PERMIT

ON-SITE SEWAGE DISPOSAL SYSTEM HOWARD COUNTY HEALTH DEPARTMENT BUREAU OF ENVIRONMENTAL HEALTH

ADDRESS: 17197 Hardy Road PROPERTY OWNER: Eugene Vajger

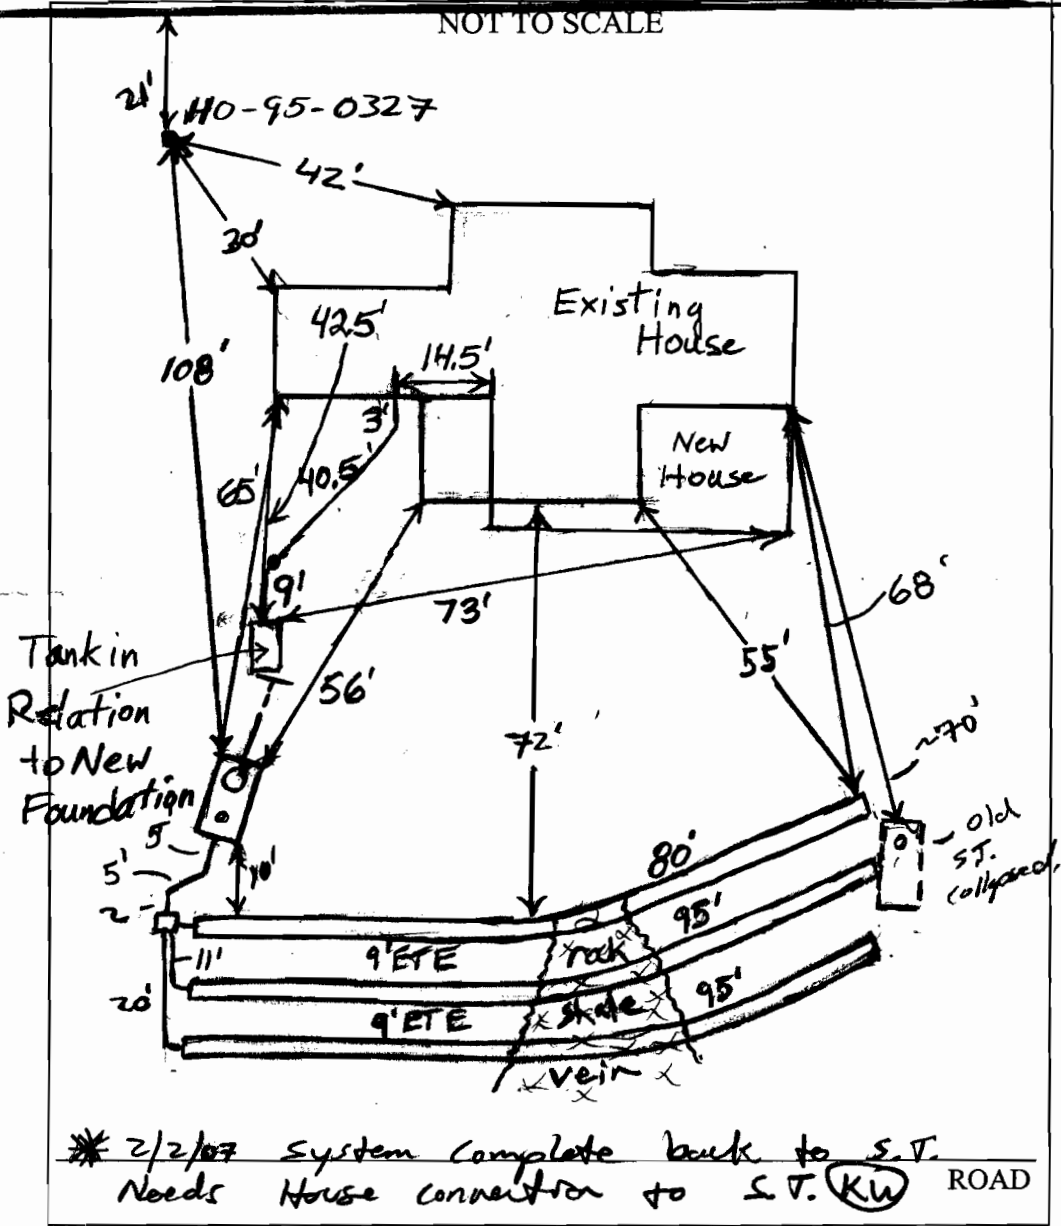
* 2/2/07 System complete back to S.T. Needs House connection to S.T. KW ROAD

PRE-CONSTRUCTION 1/18/07 Place S.T. 100' from all well setbacks. Place D box top w/ter of SRA, run 6 x 44' trenches.

INSTALLATION on contour. Do not run trenches outside SRA due to adjacent wells. KW 1/19/07 called Contractor on phone, changed trench design: set D box top left corner run 3 long trenches across entire SRA totalling ~265' of trench. Concerned about ex dry well in SRA near right lot line. Please call prior to digging up dry well for Sanitation approval.

KW 1/30/07 Contractor was unaware about calling Inspector's Dept. Health Dept. Tank set per installation. 3 Trenches dug, both 2' dug and stored. Top trench needs stone and pipe. No plumbing to end from S.T. D box not set. Noted huge shale vein mid-way thru all trenches. System needs all setbacks @ this time KW 9/26/07 House connection made. BB
